STAFF TECHNICAL POSITION ON

INVESTIGATIONS TO IDENTIFY FAULT DISPLACEMENT

AND SEISMIC HAZARDS AT A GEOLOGIC REPOSITORY

Revised Public Comment Draft - November 1991
Michael E. Blackford, and Keith I. McConnell, and Abou-Bakr Ibrahim

FIGURE 2 -- Hierarchy of Elements in the Geologic Setting.

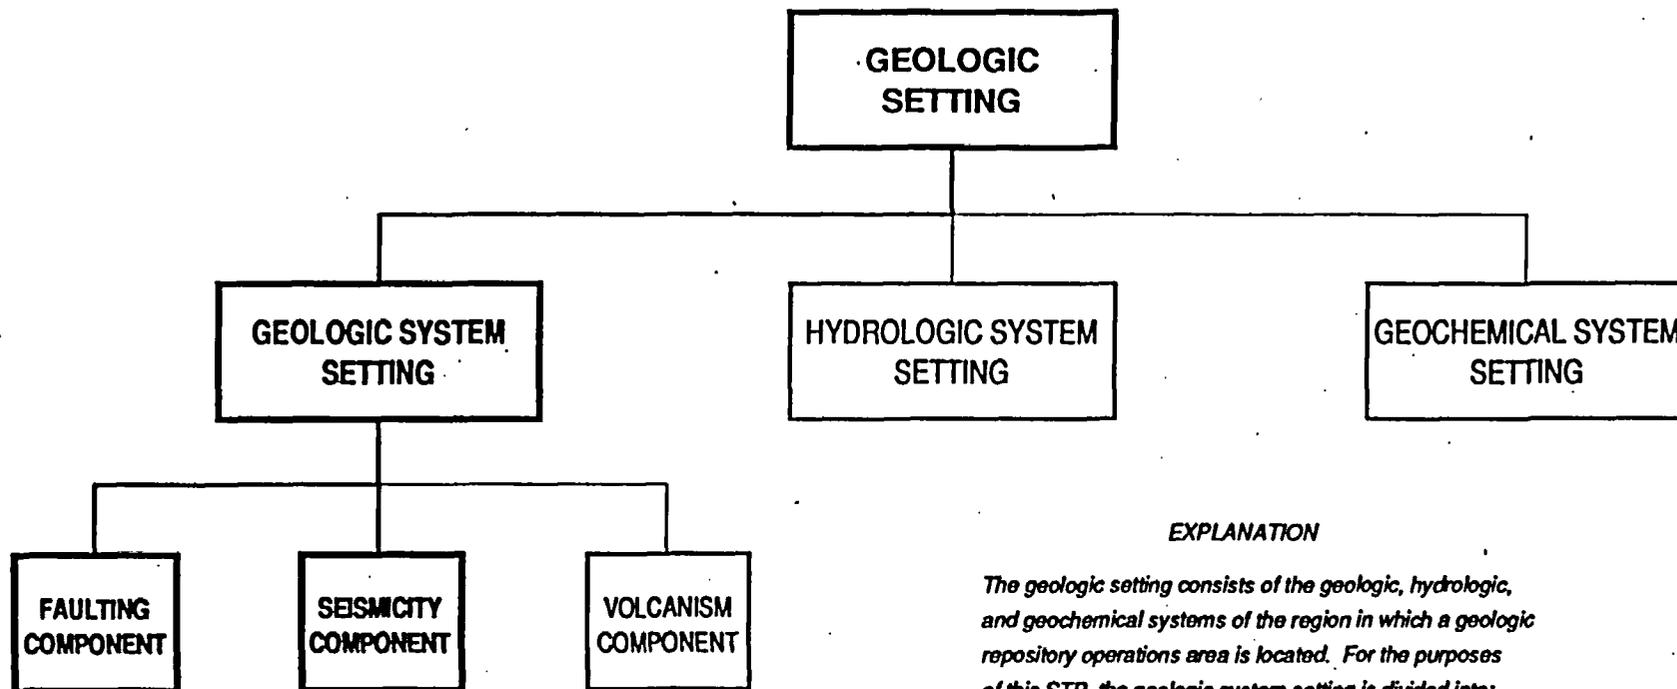
The definitions given on Figure 2, page 26 that the "region is within the geologic system [are] acting within the geologic setting" appear to be in conflict with each other and the definition for geologic setting given here. The conflict might be resolved if the glossary was expanded to include the definition(s) for the various "systems," "settings," and "components." In addition, although the "geologic setting" definition is cast in the concrete language of 10 CFR Part 60, this glossary offers an ideal opportunity to remedy shortcomings of the 10 CFR Part 60 language by expanding on that definition, particularly as it relates to the southern Basin and Range region that includes Yucca Mountain.

The staff considers that the term "region" can have varying definitions depending on the application. With respect to Figure 2, the term refers to the component setting. With respect to the definition of "geologic setting," the term refers to the sum of the component settings.
